TIE-LINE 637 WOOD-TO-STEEL PROJECT
MINOR PROJECT REFINEMENT
REQUEST FORM

Date Requested:	April 18, 2014	Report #:	002
Date Approved:	April 23, 2014	Approval Agency:	No other agency approval required.
Property Owner(s):	SDG&E Right-of-Way	Location/Milepost:	Near Structure Nos. D21 and P22
Land Use/ Vegetative Cover:	The proposed impact area occurs primarily within bare ground and non-native grassland.	Sensitive Resources:	None
Refinement / Modification From (check all that apply):			
<input type="checkbox"/> Permit	<input type="checkbox"/> Plan/Procedure	<input type="checkbox"/> Specification	<input type="checkbox"/> Drawing
<input checked="" type="checkbox"/> Other: Access Road/Overland Travel			
San Diego Gas & Electric Company (SDG&E) is proposing to utilize a different access (overland travel) to Structure Nos. D21 and P22 than the access that was originally described within SDG&E's application for a Permit to Construct (PTC) for the TL 637 Project (refer to Proponent's Environmental Assessment [PEA] Appendix 3-B).

Figure 1: MPR Overview Map

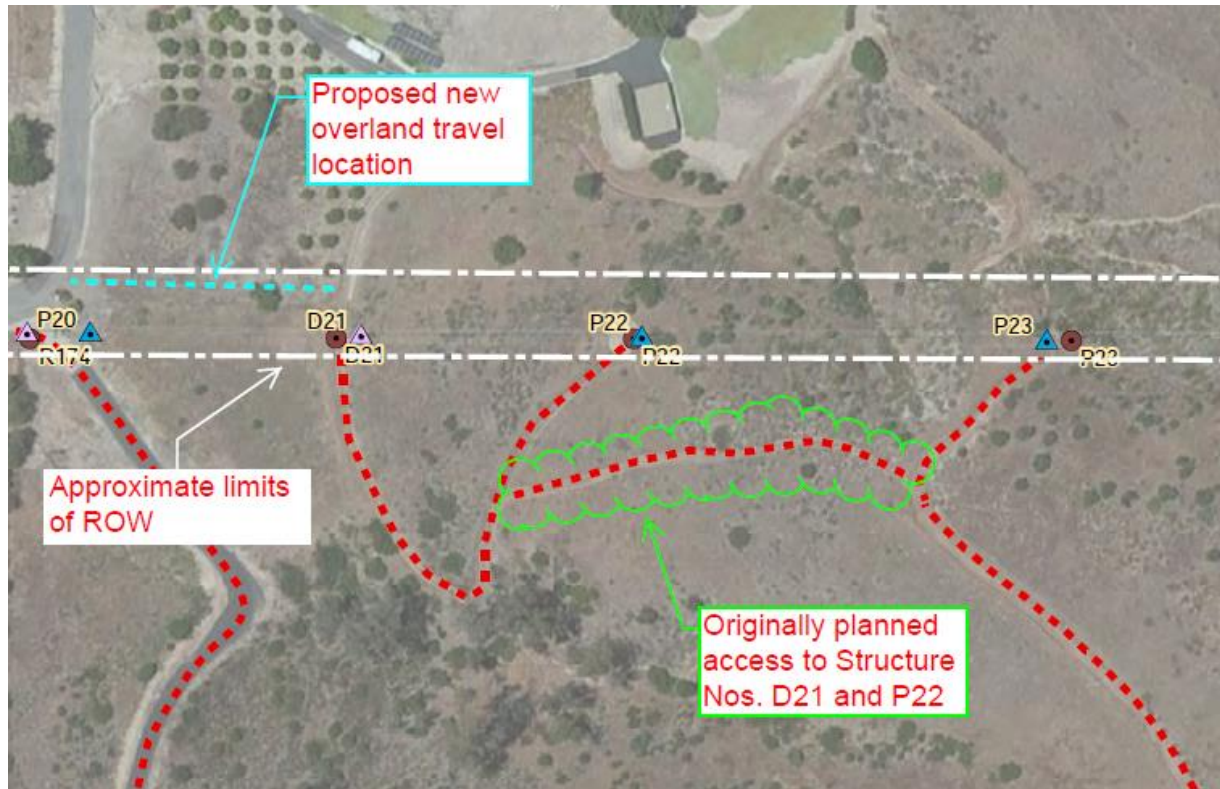
Description of Refinement			
SDG&E proposes to use alternate access (overland travel) to Structure Nos. D21 and P22. The new overland travel route would be approximately 230 feet long and would connect Creelman Lane to an existing unpaved access road near Structure No. D21 through existing ROW (see Figure 1, MPR Overview Map). A small area (approximately 900 square feet) where the proposed overland travel route would connect to the existing unpaved access road would require minor, temporary improvement (smoothing) to create a curved area for large equipment access (see Figure 2, Overland Travel Route Detail Map). This activity is considered part of the utilization of the new overland travel route for the purposes of this Minor Project Refinement (MPR) request. When the overland travel route is no longer needed for construction access, a track hoe and skiploader will re-contour the disturbed area to the original slope using a sheepsfoot attachment. Laborers will rake the sloped area for potential hydro seeding, if required. Photograph Nos. 1 and 2 depict the originally planned access road and Photograph Nos. 3 through 5 depict the proposed new overland travel route.

Original Condition:			
Access to Structure Nos. D21 and P22 was originally planned to be from an existing unpaved access road north of Structure Nos. D21 and P22. The original access was a pre-existing access road that is approximately 340 feet long (refer to Figure 1).			
Justification for Change:			
Following in-field review of the originally planned access road, construction crews identified potential safety, environmental, and logistical concerns with utilizing the originally planned access road (see Photograph Nos. 1 and 2). The originally planned access road is very steep and is in a very poorly maintained condition. Utilization of the proposed new overland travel route would result in safer working conditions and less adverse impacts to the human and natural environment.

The previously contemplated length of access road (approximately 340 feet) would have resulted in a disturbance area of approximately 4,760 square feet (area calculated assuming a 14-foot wide route over 340 linear feet between Structure Nos. P22 and P23 – refer to Figure 1).

The proposed overland travel access route (approximately 230 linear feet) and associated work area preparation are anticipated to result in a disturbance area of approximately 1,820 square feet (920 square feet for vehicle disturbance area on the overland portion and 900 square feet for the curved access area between the overland route and existing access road). This would result in a reduction in disturbance area of approximately 2,940 square feet as a result of the proposed construction activities.

Figure 2: Overland Travel Route Detail Map

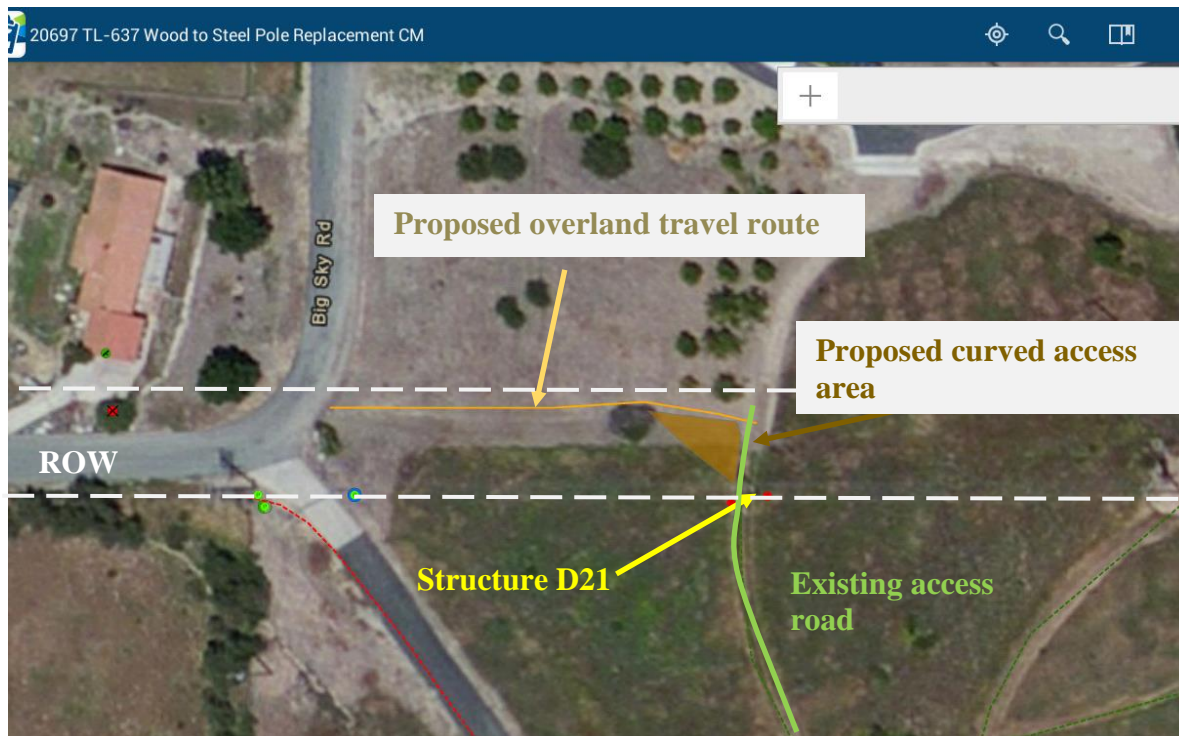
Figure 1 (extracted from PEA Appendix 3-B, Sheet 4 of 50) depicts the originally proposed access route and the newly proposed overland travel locations. Figure 2 depicts the proposed new overland travel location and temporary turning radius disturbance area.
